UNITED STATES PATENT AND TRADEMARK OFFICE

APPLICATION NO.	FILING DATE	FIRST NAMED INVENTOR	ATTORNEY DOCKET NO.	CONFIRMATION NO.
10/821,907	04/12/2004	Stephan Kleppner	R.305819	2434
7590	06/12/2007		EXAMINER	
RONALD E. GREIGG			RODRIGUEZ, WILLIAM H	
GREIGG & GREIGG P.L.L.C.				
Suite One			ART UNIT	PAPER NUMBER
1423 Powhatan Street				3746
Alexandria, VA 22314				
			MAIL DATE	DELIVERY MODE
			06/12/2007	PAPER

FINAL REJECTION

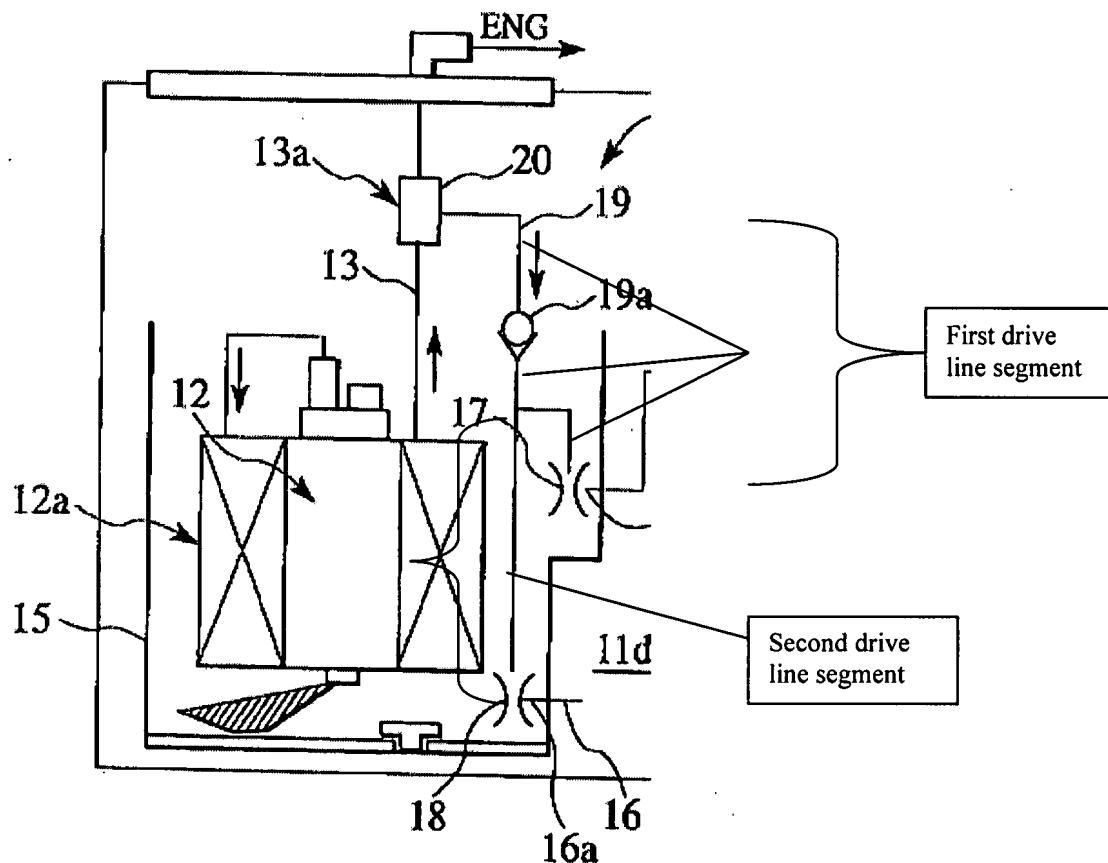
3. Claim 12 is rejected under 35 U.S.C. 102(b) as being anticipated by **Tanimura (US 2003/0062031)**.

Tanimura teaches an apparatus for delivering fuel from a tank to an internal combustion engine of a motor vehicle, comprising: a reservoir 15 located in the tank 11, a fuel supply pump 12, at least two vertical suction jet pumps (17, 18) connected to a drive line 19, the drive line of the jet pumps connected to a pressure line 13 downstream of the fuel supply pump, one of said at

least two jet pumps connected to a pan region and the other to a saddle region of the tank containing the reservoir, said drive line comprises a first segment leading to the jet pump 17 and a second drive line segment leading to the other jet pump 18, *wherein said at least one check valve 19a is provided in the first drive line segment.* See particularly Figure 1 below.
